Amendments to the Drawings:

REMARKS

ALUJA.0102CIP

Fig. 16

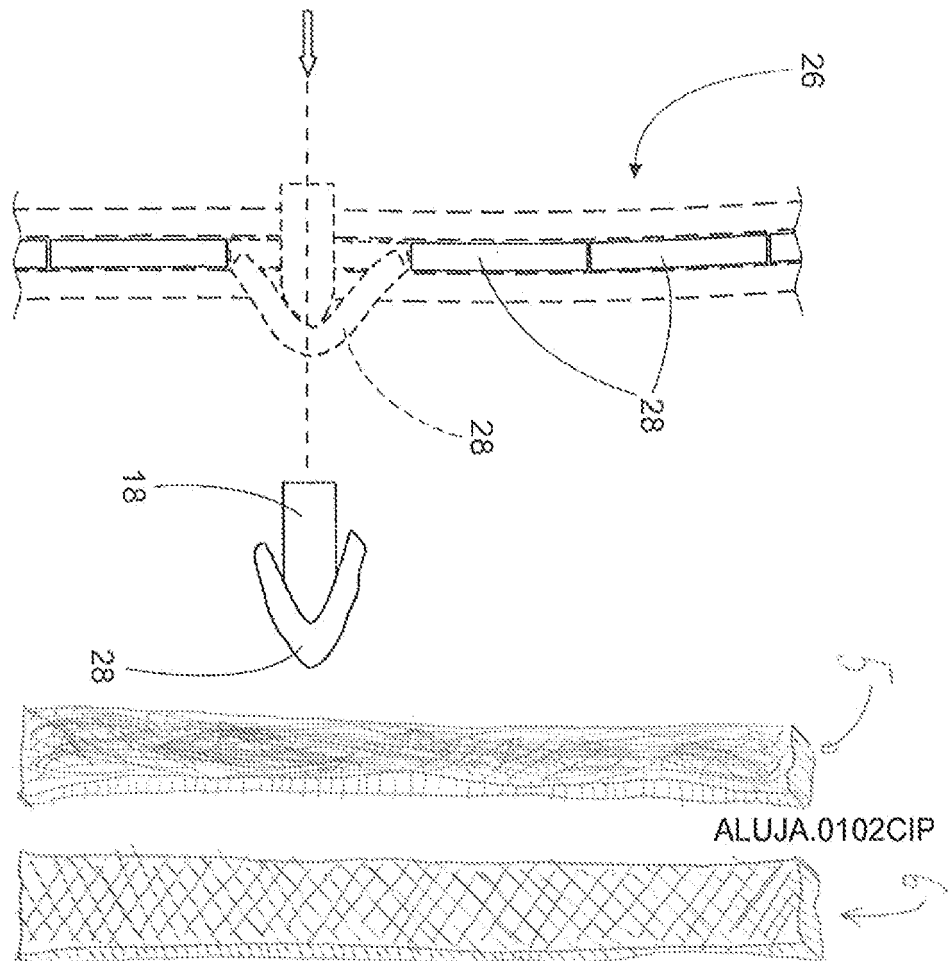
The attached sheet of drawings includes changes to Fig. 16. This sheet, which includes Fig. 15-16, replaces the original sheet including Fig. 15-16. In Fig. 16, elements 5 and 6 from Fig. 1 have been added to Fig. 16.

In the Office Action, the Examiner has again objected to the drawings under 37 CFR §1.83(a) in that the drawings are deemed not to show every feature of the invention. Specifically, the Examiner contends that the “at least one projectile stopping panel” (Claims 15, 16), “the impact cushioning panel” (Claim 28), and “the projectile stopping panel comprising loosely-entangled fibers” (Claim 29) are not shown in the drawings. In the previous Office Action, Applicant pointed out to Examiner that these features were already shown in FIGS. 1 and 9. During an informal telephone conversation with Examiner on August 8, 2006, Examiner noted that these features are not shown in FIGS. 15 and 16, which represent specie E elected with traverse by Applicant pursuant to a restriction requirement. Examiner also stated that he would not look outside FIGS. 15 and 16 for the above referenced features.

Pursuant to Examiner’s suggestion that he will not look at any other figures other than FIGS. 15 and 16 for the features of the invention, replacement drawing sheets are attached to this response clearly depicting the “at least one projectile stopping panel” (Claims 15, 16), “the impact cushioning panel” (Claim 28), and “the projectile stopping panel comprising loosely-entangled fibers (Claim 29) in FIG. 16. Specifically, the “at least one projectile stopping panel” and “the projectile stopping panel comprising loosely entangled fibers” are identified by reference numeral 5. The “impact cushioning panel” is identified by reference numeral 6.

No new matter has been entered because these amendments to the drawings are clearly supported by the original disclosure. In paragraph 0069 of the published application, the description of FIG. 16 states that the bullet is “trapped into the mass or against the surface of any further ballistic panel, such as the panels of FIGS. 1 and 9.” Therefore, the ballistic panels of FIGS. 1 and 9 are incorporated by reference into the description of FIG. 16. Consequently, FIG. 16 has been amended to include the ballistic panels identified by the reference numerals 5 and 6

Paragraph 0042 of the published application refers in the description of FIG. 1 to “at least one projectile-trapping panel 5.” Likewise, the specification at paragraph 0070 refers to “at least one projectile-stopping panel, or trapping panel”, which indicates that the terms “projectile trapping panel” and “projectile stopping panel” are used interchangeably. Such panel is now clearly depicted in FIG. 16 and identified by the reference numeral 5.

The “projectile stopping panel comprising loosely entangled fibers” in claim 29 is also shown in FIG. 16. Applicant respectfully refers Examiner to the preceding paragraph indicating that the terms “projectile stopping panel” and “projectile trapping panel” are used interchangeably. To the extent Examiner believes that the “loosely entangled fibers” portion of claim 29 is not shown, Applicant refers Examiner to paragraph 0055 of the specification, wherein it is disclosed that “the projectile-trapping panels 5 ... may comprise a mass of loosely-entangled microfibers 15, FIGS. 1 and 2.” The same paragraph goes on to state that “the term ‘microfiber’ must be understood as encircling all kind of fibers, filaments, threads and the like.” The term “loosely entangled” is defined in paragraph 0057 of the specification. The term “loosely entangled” is also described and claimed in U.S. Patent No. 6,684,468, col. 4, l. 45 through col. 5, l. 12 and claim 1. Therefore, “the projectile stopping panel comprising loosely entangled fibers” in claim 29 is now depicted in FIG. 16 and identified by reference numeral 5.

Applicant also respectfully submits that the “impact cushioning panel” referred to in claim 28 is now shown in FIG. 16. In paragraph 0043 the specification discloses “at least one impact cushioning panel 6, see FIG. 1”. Again, Applicant respectfully refers Examiner to the description of FIG. 16, paragraph 0069, which also refers to FIG. 1 and incorporates the ballistic panels of FIG. 1 by reference into the description of FIG. 16. Because the “impact cushioning panel”, “the projectile stopping panel”, and “the projectile stopping panel comprising loosely entangled fibers” originally shown in FIG. 1 are now shown in FIG. 16 and identified by the reference numerals 5 and 6, Applicant requests that Examiner withdraws his objection under 37 C.F.R. 1.83(a) that these features are not shown in the drawings.
